# TELECOMMUNICATIONS COMMITTEE

TUESDAY, JANUARY 8, 2019  
9:00 A.M.

DATE: January 3, 2019  
TO: Telecommunications Committee  
FROM: Planning Division  
SUBJECT: **WIRELESS TELECOM FACILITY (WTC17-00026) – LAURA CASTRO (J5 INFRASTRUCTURE PARTNERS)**

## WIRELESS PLANNING MEMORANDUM

**Figure 6:** Proposed Pole and Recommended Lesser Intrusive Pole (Source: Google Maps, Annotated by Dr. Kramer).

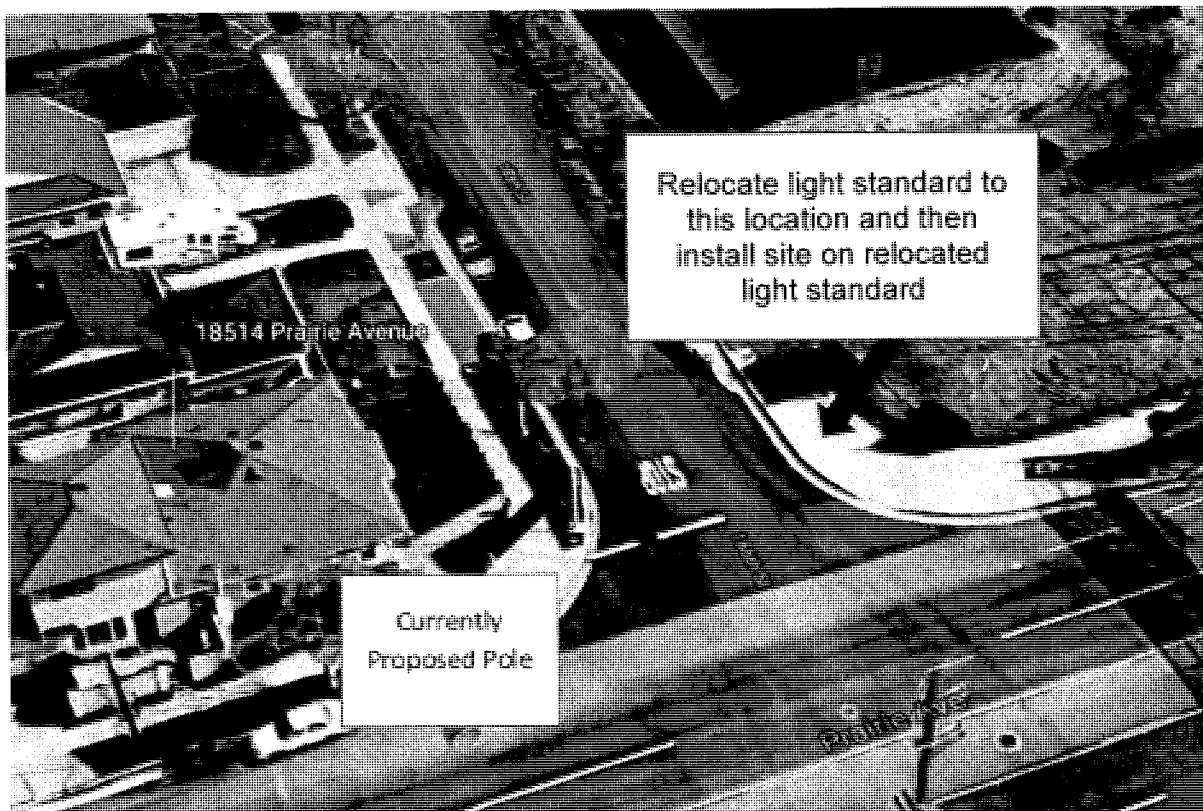
Based on a desktop review of the area surrounding the proposed location, TLF believes that relocating the existing light standard to the opposite side of the street on 186<sup>th</sup> at Prairie Street appears to offer a meaningfully better aesthetic alternative in comparison to the proposed location. See Figure 6.

**Figure 1:** Antenna, Antenna skirt enclosing Diplexers, Fiber Node, 2 RRUs (Missing visual elements, e.g. new Pole location, RF signage, fiber pull box, connecting cables etc.) (Source: Photo Simulations provided by Applicant).

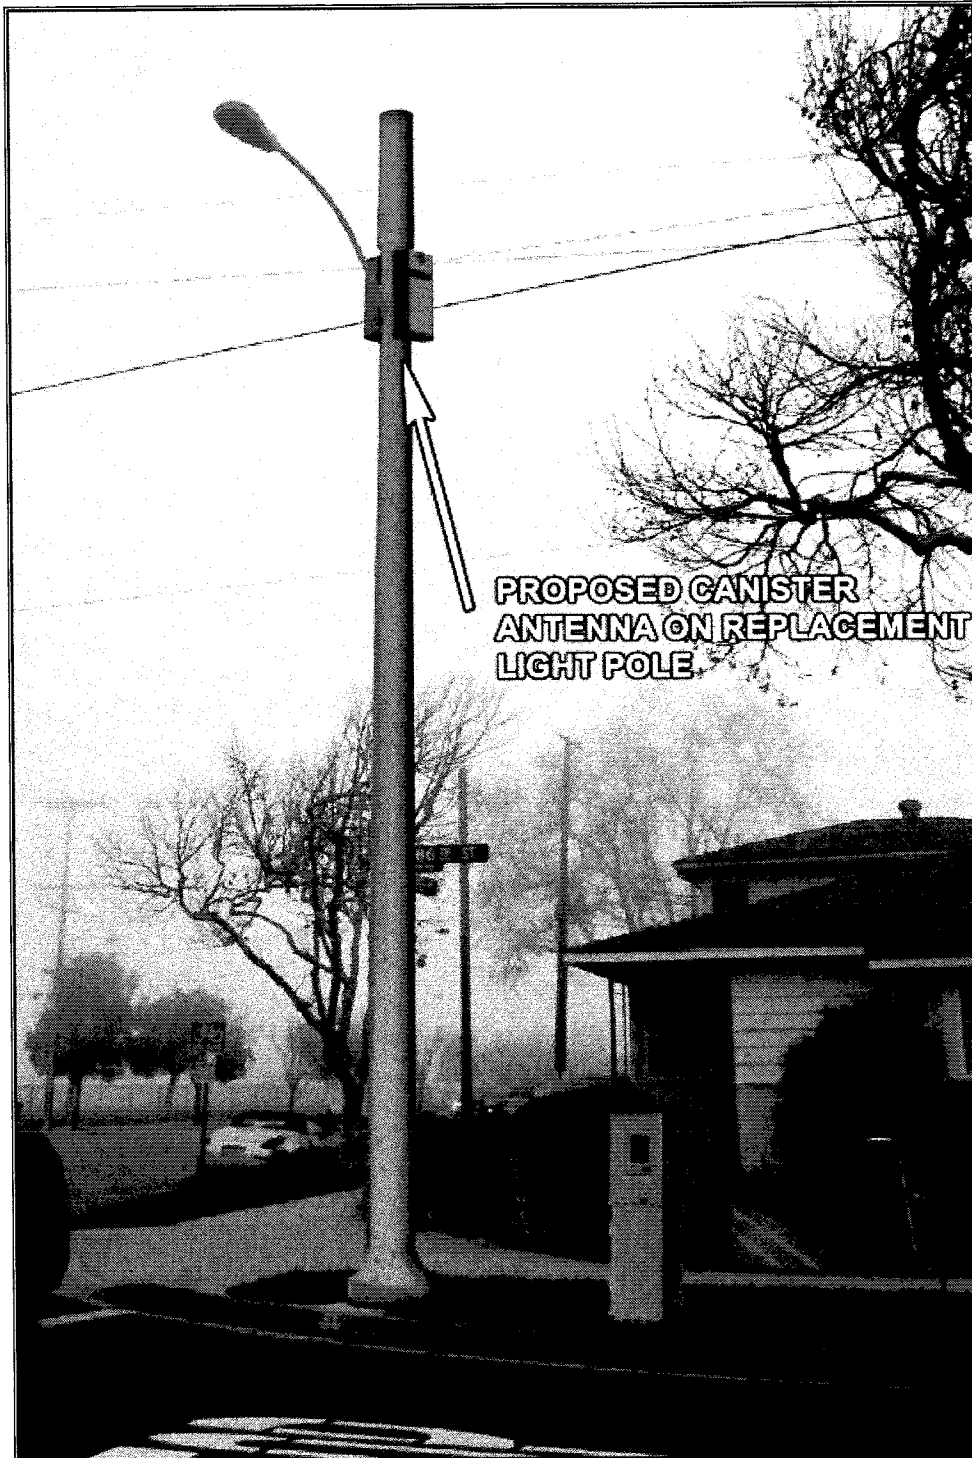
- Section 6.05 is not separately provided, however the Applicant provided an EBI RF Report.
- Section 7.01–subsection 2: Missing elements on the photo simulations (e.g., new Pole location, RF signage, fiber pull box, connecting cables, etc.) See Figure 1 below.

Figure 1: Proposed Pole (Source: Plans page A-3 panel 1).

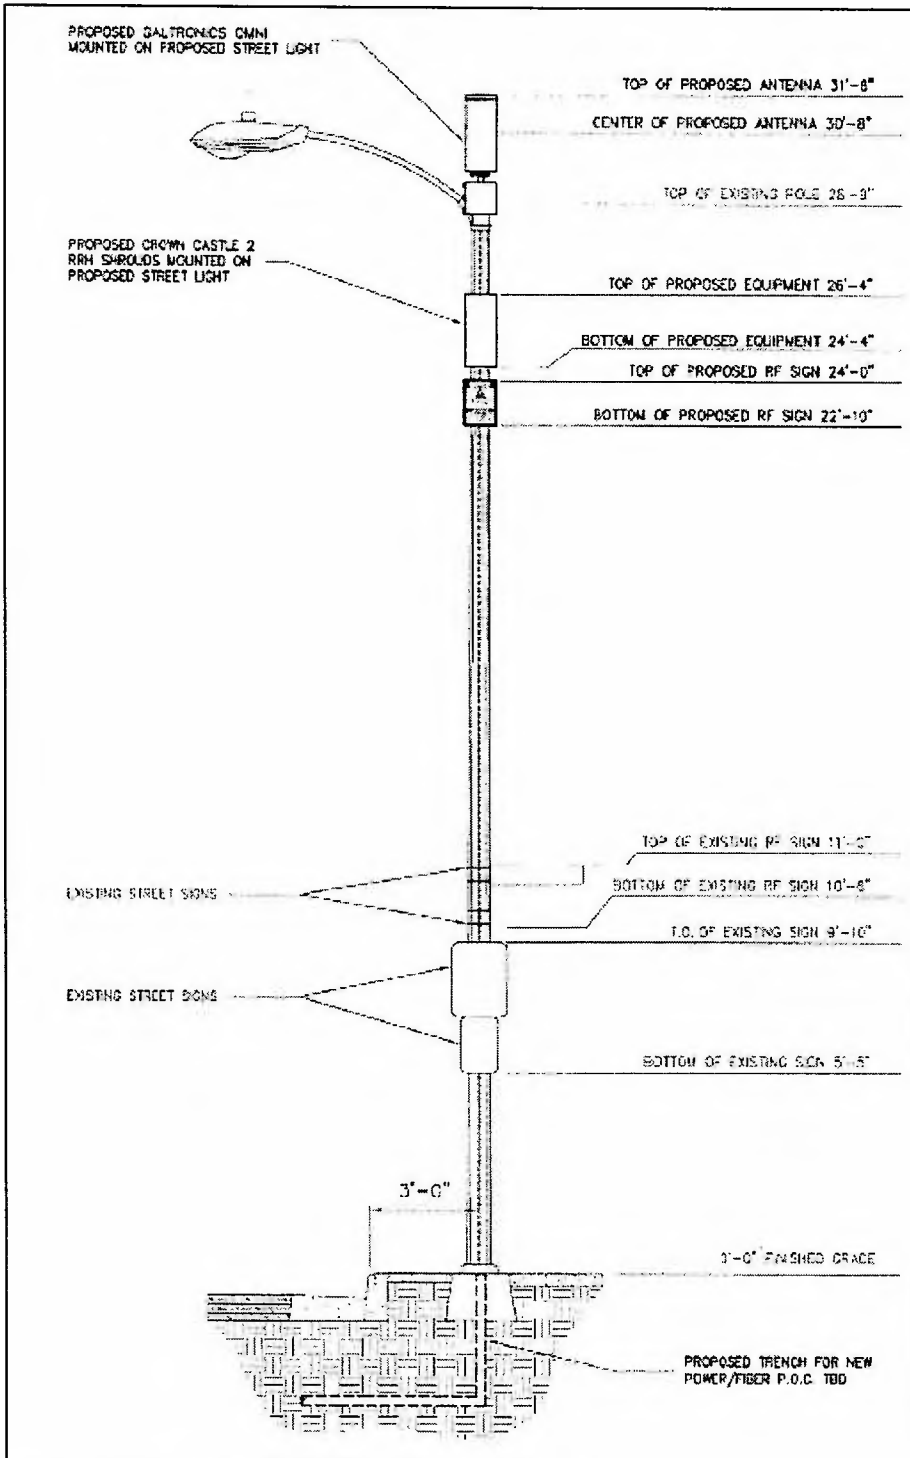
TLF notes that the Plans pages A-2 and A-3 both panels 1 and 2 depict an existing RF sign on the existing pole. We recommend a confirmation of the existing street sign inventory to be relocated onto the Pole. See Figure 1

Figure 2: Power/Fiber connections (Source: Plans page A-1 panel 2).

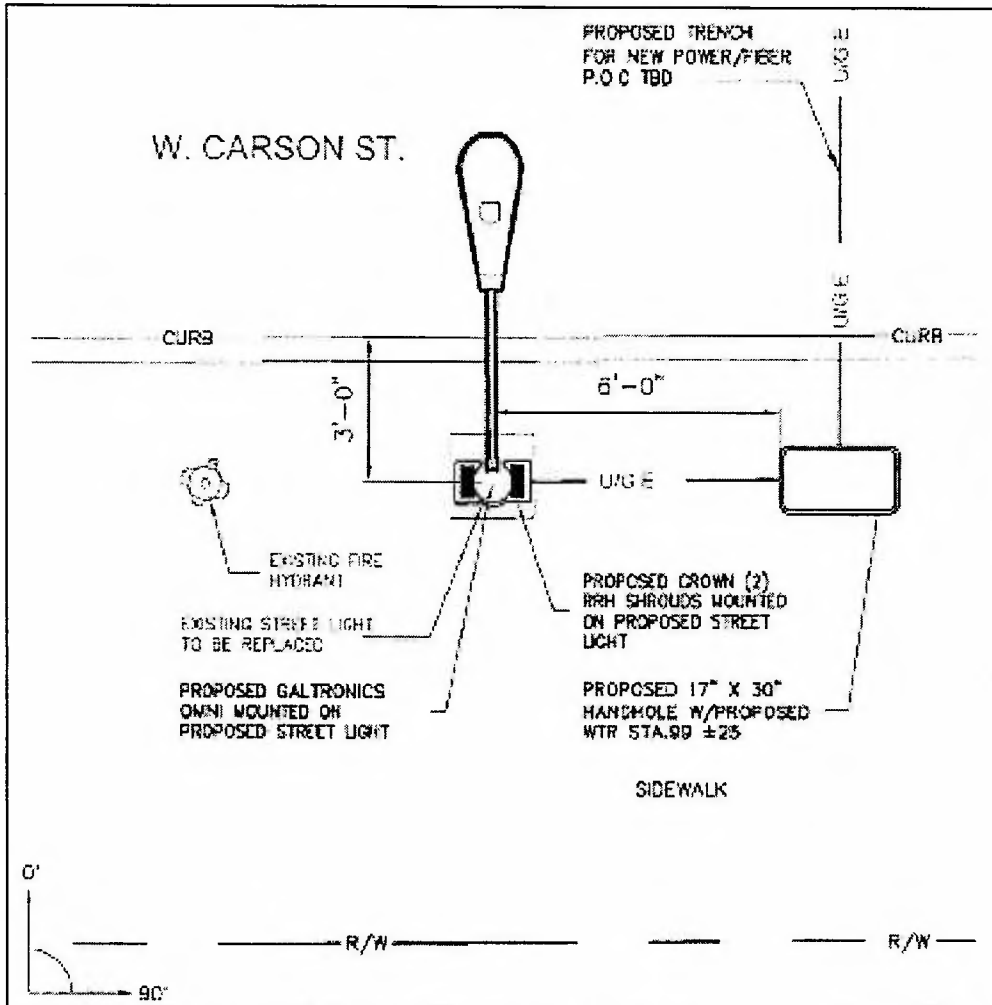
For its electrical and fiber connections, the Applicant proposes a new underground power/fiber trench for power/fiber to run from an existing underground location. We note that the Plans page A-1 panel 2 show that the power/fiber run is TBD (to be determined). See Figure 2 below.

We note that the Development Application mentions that two underground vaults will be installed. See Figure 3. The Plans and the Development Application do not match since no underground fiber is depicted on the Plans. All materials submitted for this specific project must be internally consistent for project design reliability and clarity.

Figure 1: Proposed Pole (Source: Plans page A-3 panel 1).

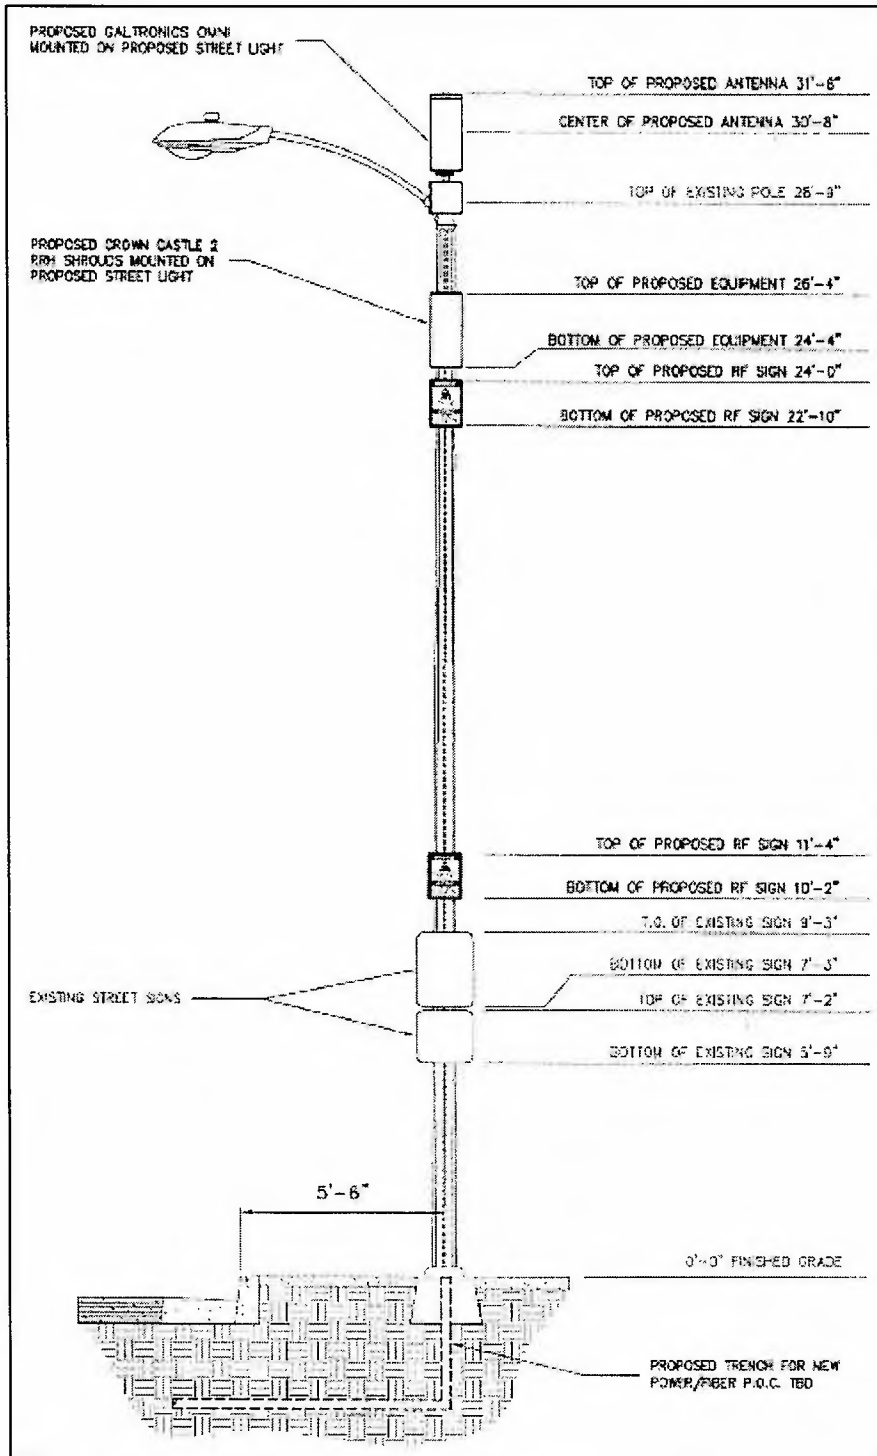
For its electrical and fiber connections, the Applicant proposes a new underground power/fiber trench for power/fiber to run from an existing underground location. We note that the Plans page A-1 panel 2 show that the power/fiber run is TBD (to be determined). See Figure 2 below.
